FORMAL OBJECTION TO PLANNING APPLICATION DC/26/0945

Reference: DC/26/0945

Proposal: Variation of Condition 1 of previously approved application reference DC/22/0773 (Variation of Condition 1 of previously approved application DC/19/1707) – Amendment to buffer strip to reflect an additional swale with landscaping (part retrospective).

Site: Abingworth Meadows Phase 3, Thakeham

drawing no: BELL23356 - 11 Sheet 6 of 8

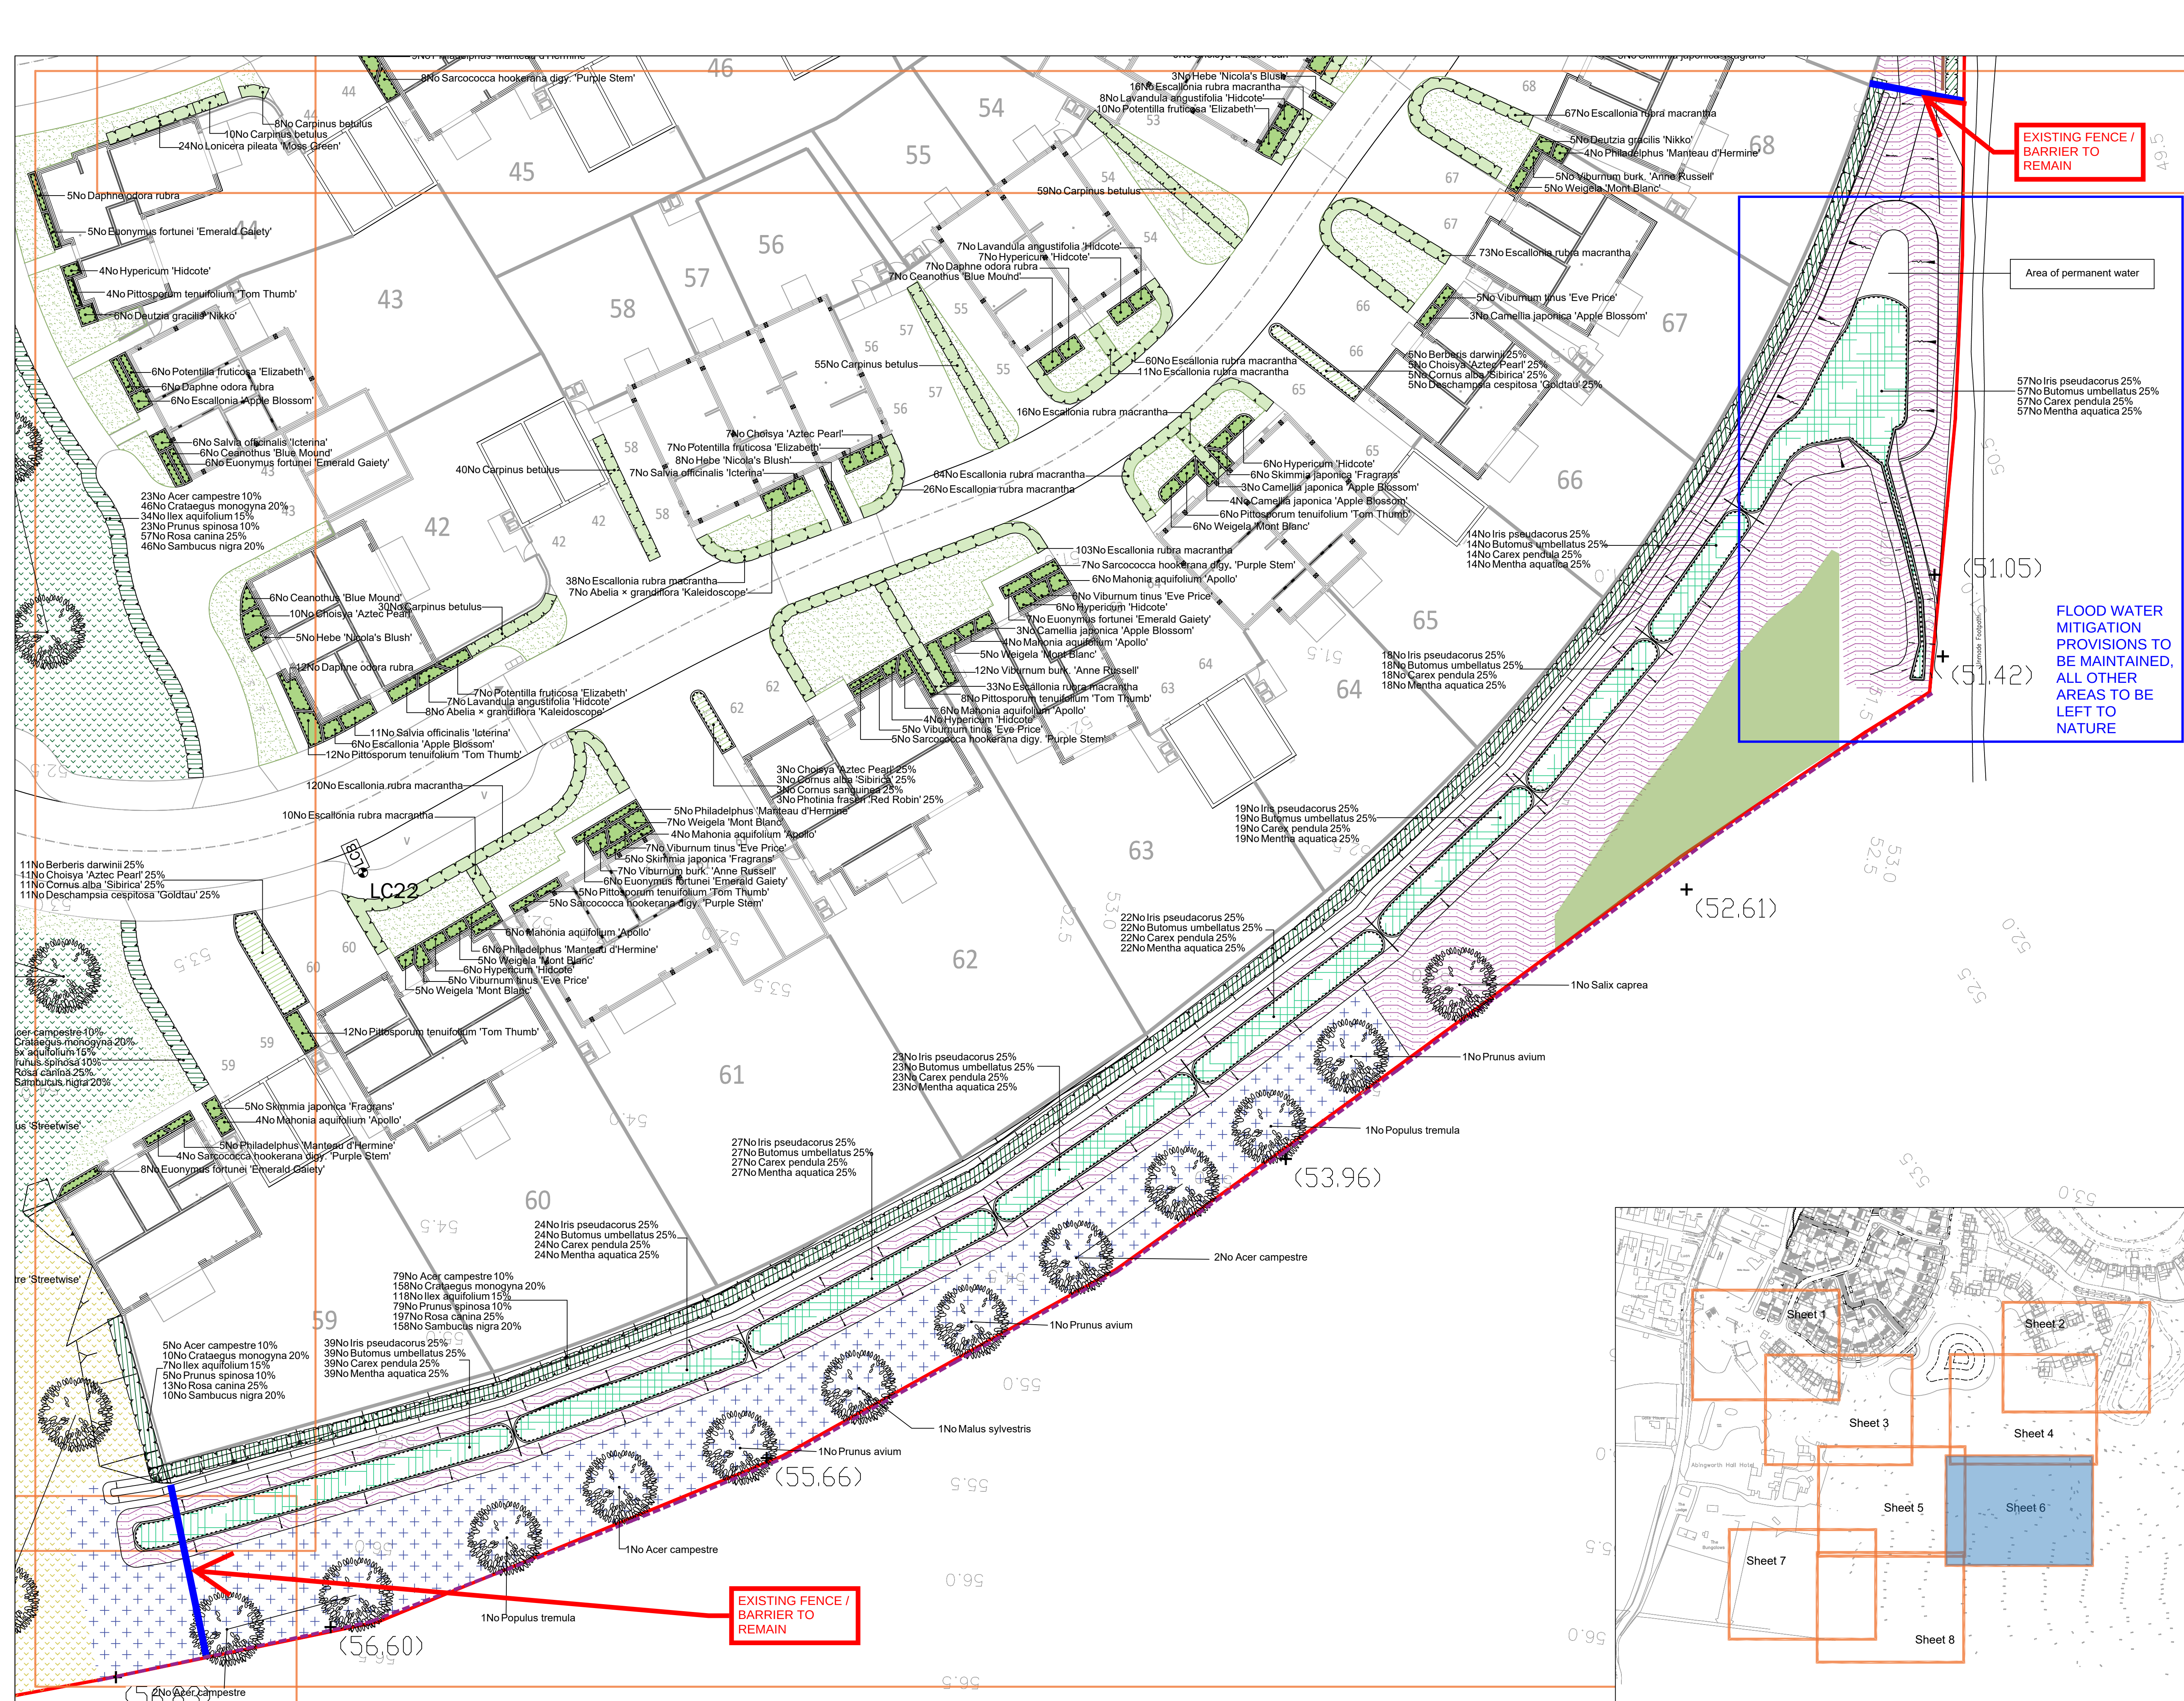
- Thakeham Parish Council Representation Regarding Proposed PROW dated 23 December 2025.
- Bellway Landscape Drawing BELL23356-11 Sheet 4 of 8 (showing proposed 1.2m high vehicular access five-bar timber gate).
- Bellway Landscape Drawing BELL23356-11 Sheet 6 of 8 landscape proposals.
- 4.1 Boundary fencing arrangements: "the buffer area, which will be managed for nature with no right of pedestrian access."
